The Calabasas Coalition™

July 2, 2019

Re: West Village at Calabasas EIR Comments - Calabasas Planning Commission.

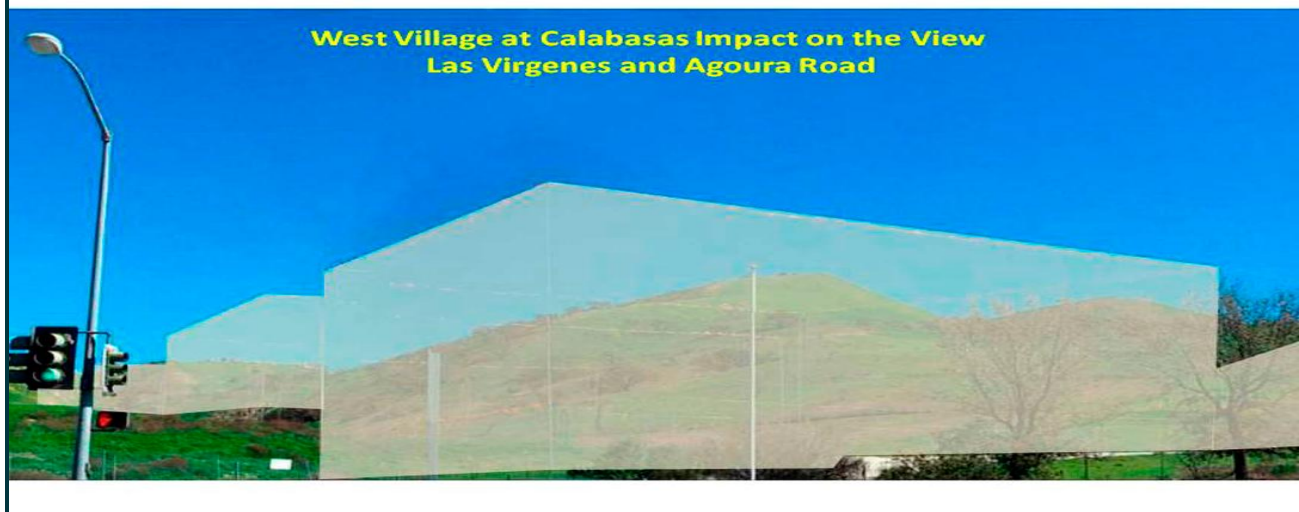
It should be noted that photo simulations for this impact on the view in the EIR are from the Jack-in-the-Box on Agoura Road, several hundred feet west of Las Virgenes Road. The impact on the view depicted in that simulation is not nearly as impactful as it would be if it were from Las Virgenes Road.

The picture below is a photograph taken from the southwest corner of Agoura and Las Virgenes Roads that includes the story poles on the site that depict the buildings' actual mass, size, and impact on the view. This is what people will see when stuck in traffic at this intersection or when walking or driving by the proposed project. The views of the hillsides and ridgelines will be blocked by the buildings. THE VIEW IMPACTS CANNOT BE MITIGATED.

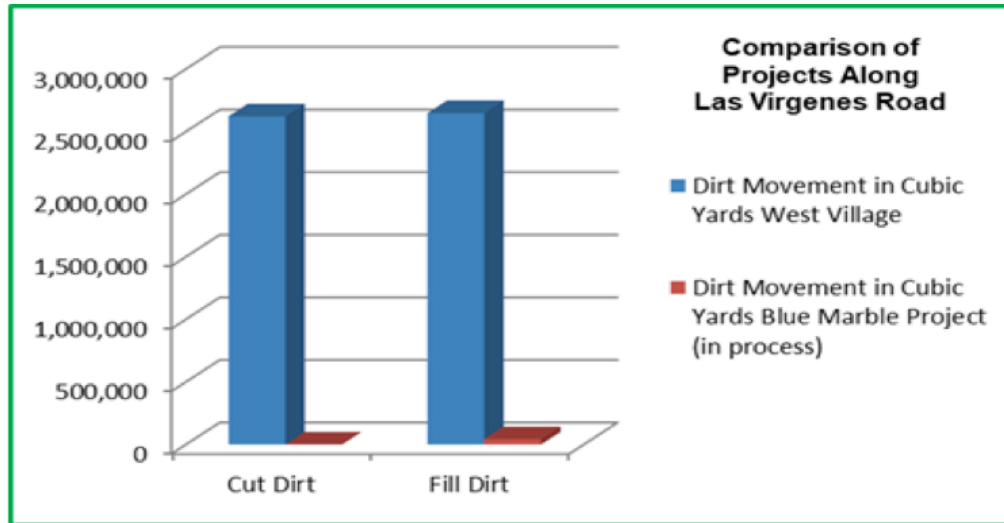
The project would involve grading of approximately 36 acres of the site’s natural landforms, which are marked by natural hillsides, oak trees, seep-fed wetlands, and ephemeral drainages. The proposed grading would involve re-contouring of the existing hillsides and filling of the existing canyon to create building pads for 15 three-story buildings.

In order to remediate an existing ancient landslide feature on the project site, the project would involve approximately 2,403,418 cy of cut and an estimated 2,406,971 cy of fill. An additional 218,770 cy of cut and 240,785 cy of fill is also proposed as non-remedial site grading.

**THIS IS MORE THAN 10 TIMES THE AMOUNT OF GRADING DONE ON THE PAXTON/BLUE MARBLE SITE.**
